Item Name: Aft Crosstube - High 206L / L1 / L3 / L4

DRAWING NO. D206-667-243	TITLE CROSSTUBE ASS'Y (206L HIGH AFT)	REV. C	DART AEROSPACE LTD ENGINEERING ORDER		D.E.O. NO. D206-667-243-C-1	SHEET NO. SHEET 1 OF 1	SCALE NTS
DRAWN <i>q</i>	CHECKED <i>ASS</i>	MFG. APPR. <i>RB</i>	APPROVED <i>MD</i>		DE APPR. <i>#</i>		
DATE 11.07.15	DATE 11.07.20	DATE 11.07.21	DATE 11/07/21		DATE 11.07.21

PURPOSE:

REPLACE MAGNOBOND WITH PROSEAL.

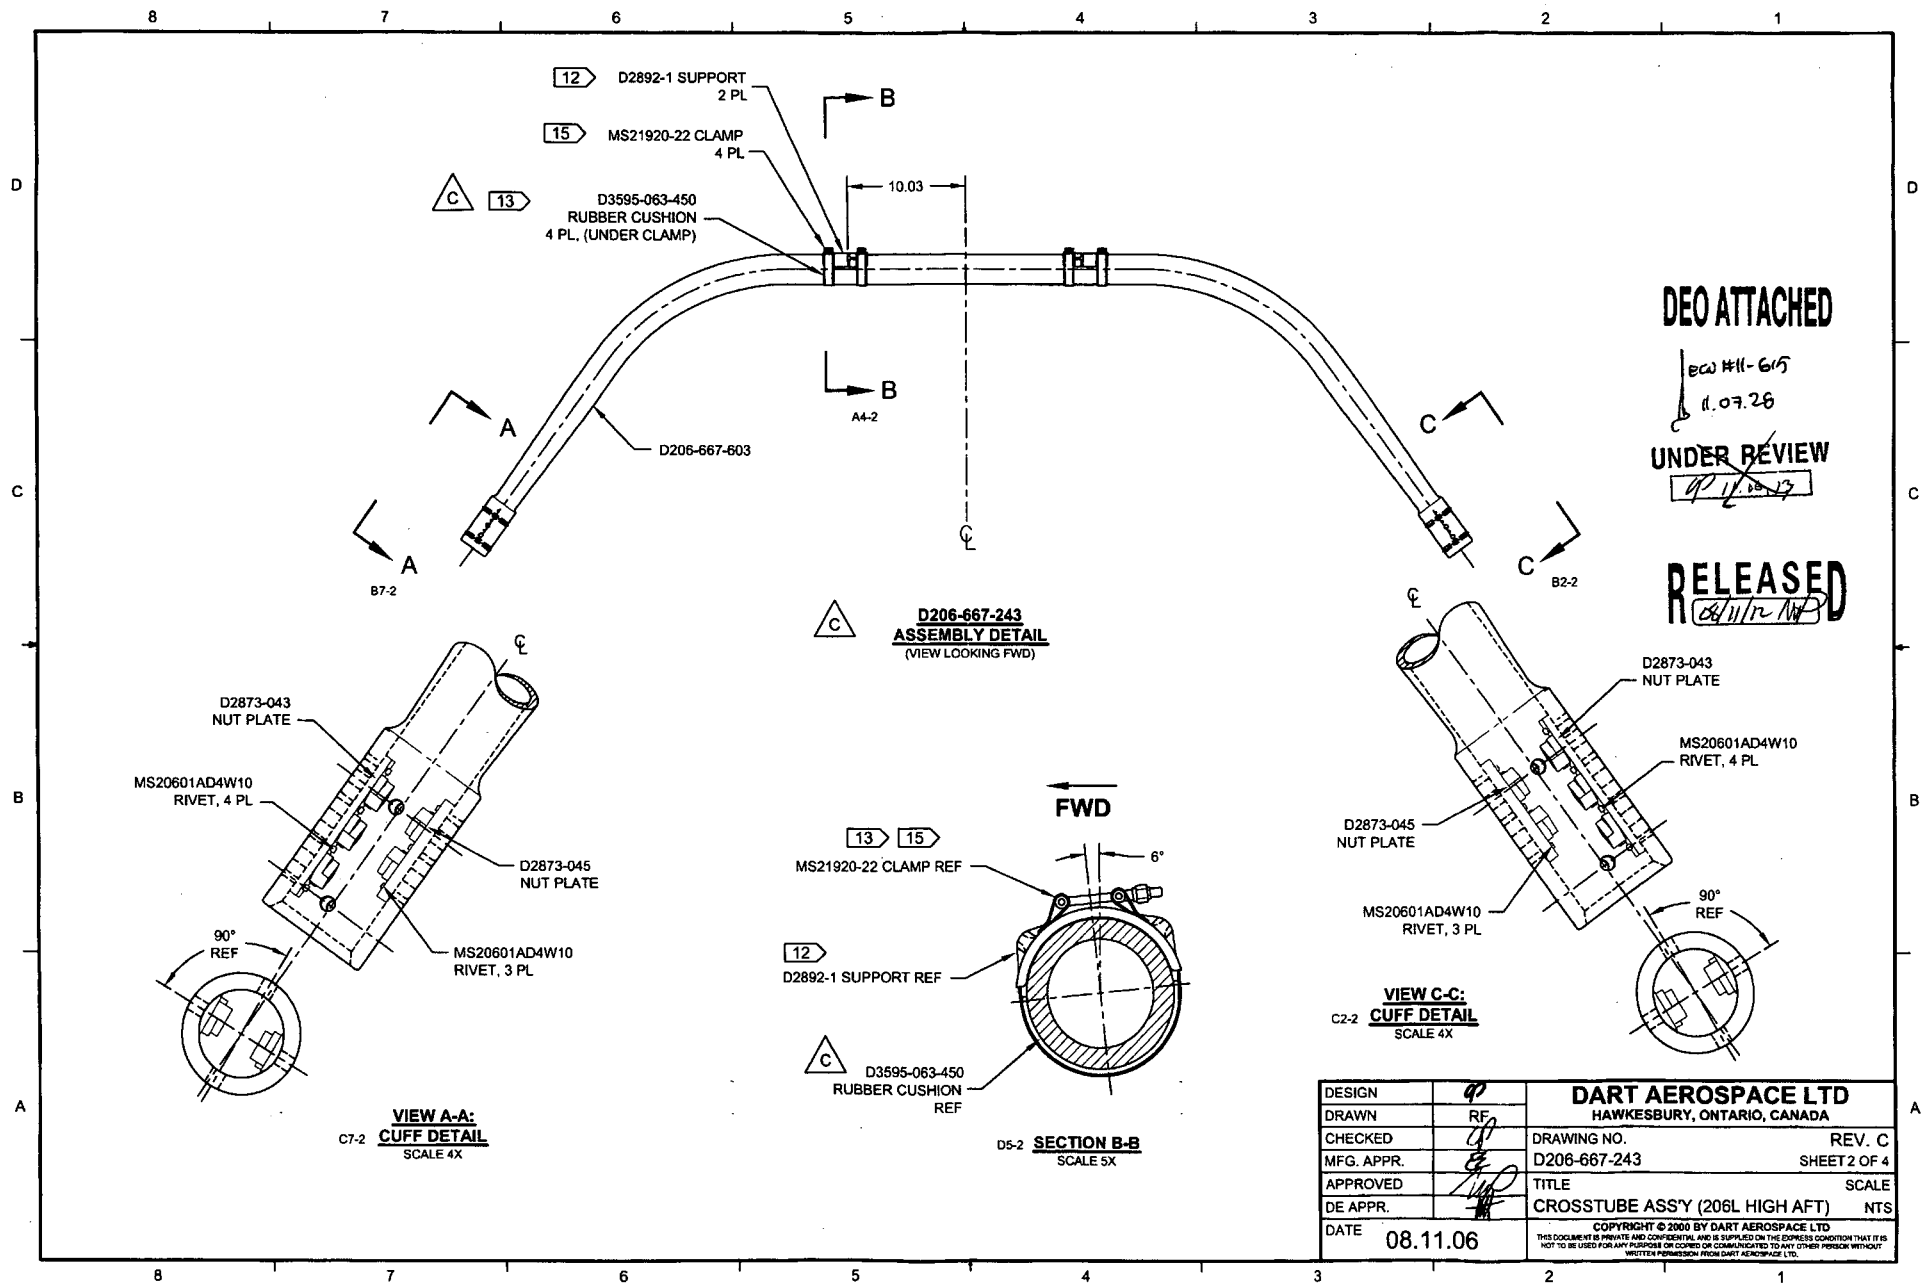
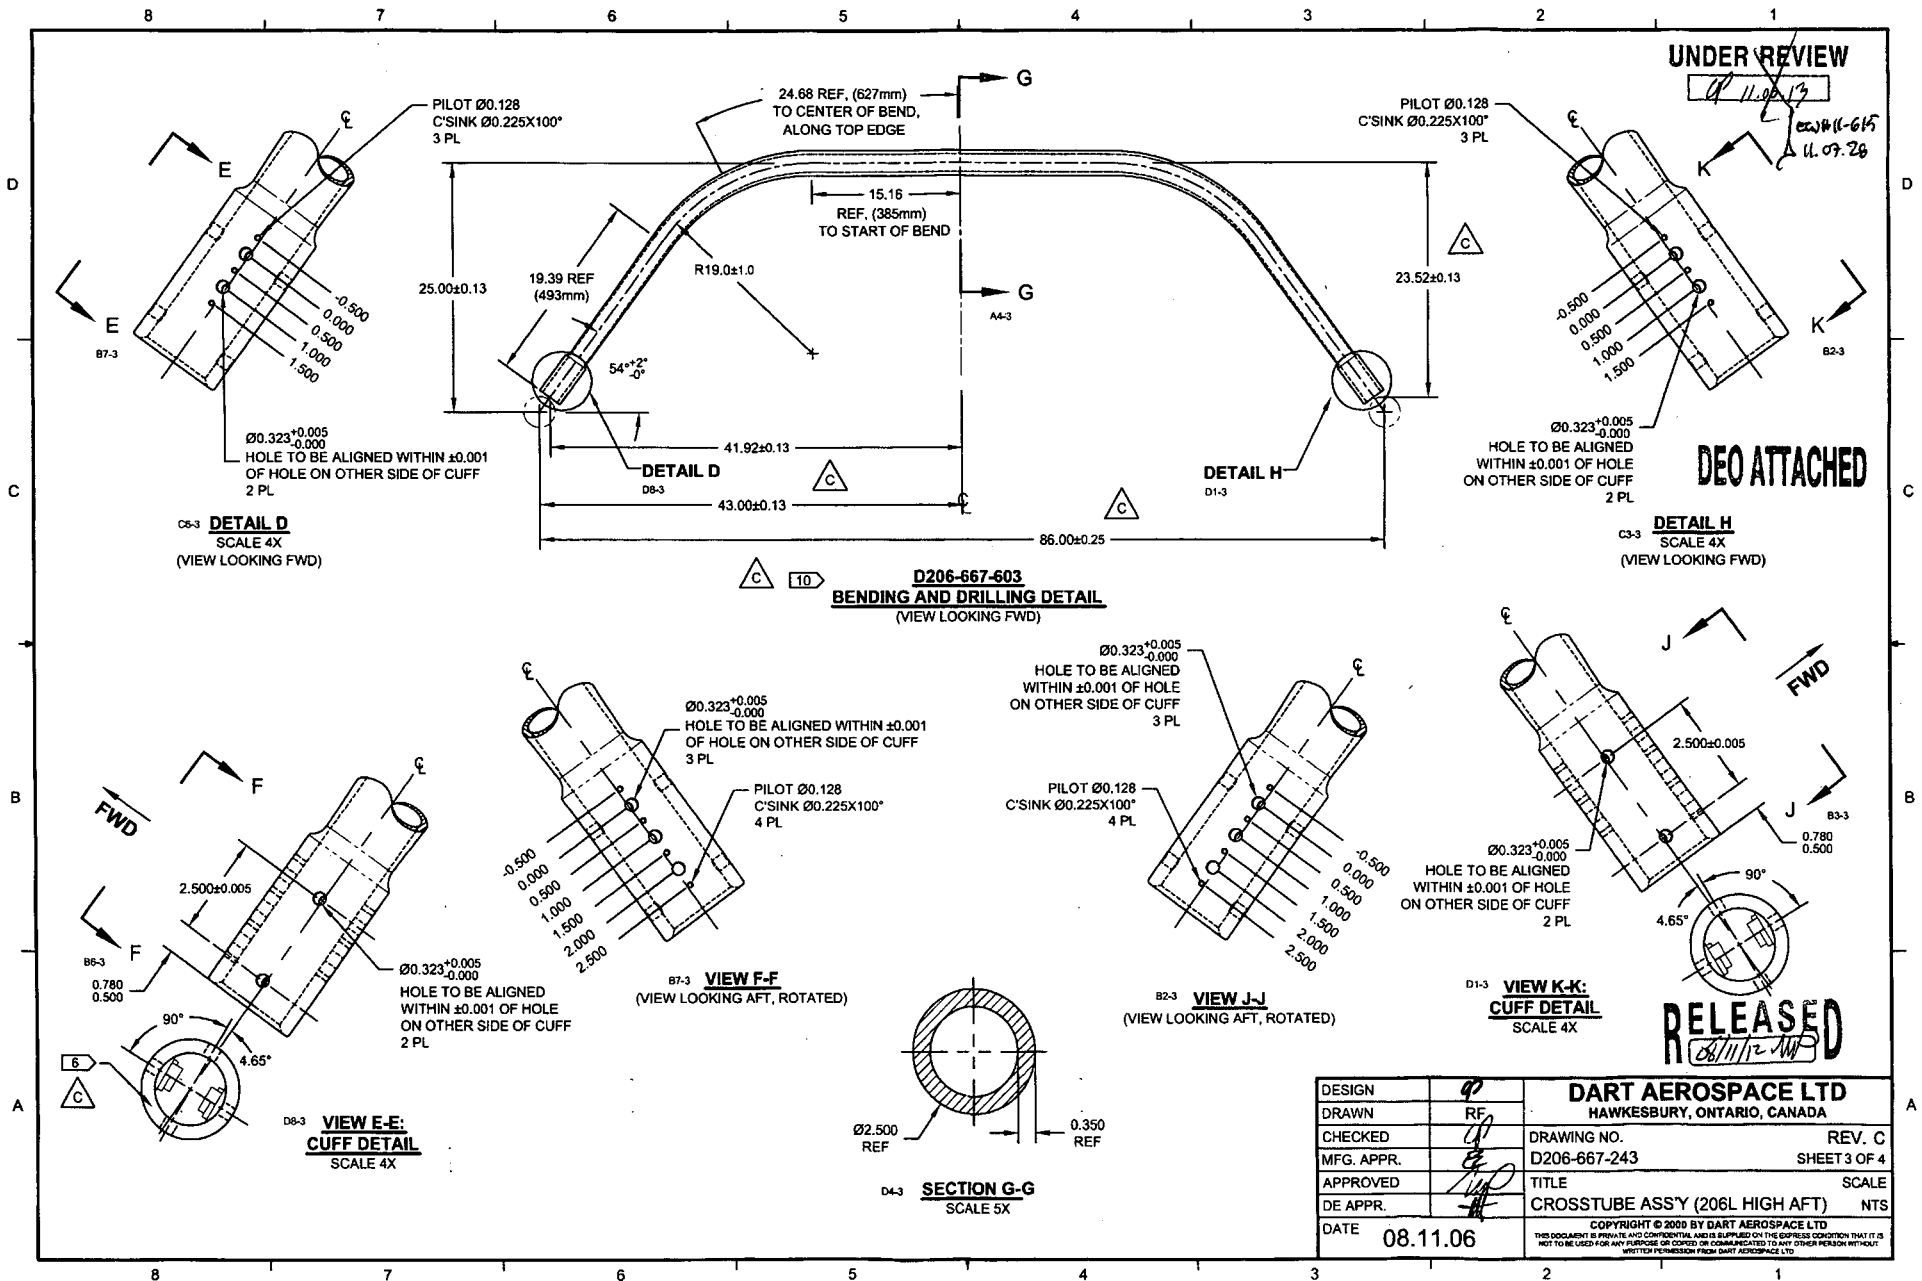
WAS:

9	A/R	MAGNOBOND 6398	ROCKWELL SPECIFICATION RBO-120-023 ADHESIVE (TEXTRON/BELL SPEC. 299-947-100, TYPE II, CLASS 2 ADHESIVE)
---	-----	----------------	---

WAS:

- 12) INSTALL D2892-1 SUPPORT USING 0.03" TO 0.06" THICK LAYER OF MAGNOBOND 6398 PER QSI 015. LET CURE FOR 12 HOURS AFTER INSTALLATION AND PRIOR TO PACKAGING.
- 15) TORQUE CLAMPS 80 TO 100 IN-LB. ENSURE AT LEAST 1.5 THREADS SHOWING IN SAFETY AND THAT NUT HAS NOT BOTTOMED-OUT AFTER TORQUING.

IS:

Item	Qty -243	Part Number	Description
9	A/R	PROSEAL 890 B-2	SEALANT, AMS-S-8802 CLASS B-2

IS:

- 12) TO INSTALL D2892-1 SUPPORT: ABRABE MATING SURFACE OF SUPPORT AND CROSSTUBE WITH 180-GRIT SANDPAPER AND REMOVE RESIDUE WITH MEK (OR EQUIVALENT). APPLY A 0.04" TO 0.07" THICK LAYER OF PROSEAL 890 CLASS B-2 (OR AMS-S-8802 CLASS B-2) SEALANT TO MATING SURFACE OF SUPPORT.
- 15) TORQUE CLAMPS 80 TO 100 IN-LB. ENSURE AT LEAST 1.5 THREADS SHOWING IN SAFETY AND THAT NUT HAS NOT BOTTOMED-OUT AFTER TORQUING. **PRIOR TO PACKAGING, RE-CHECK TORQUE ON CLAMPS AFTER PROSEAL 890 SEALANT HAS CURED FOR 72 HOURS.**
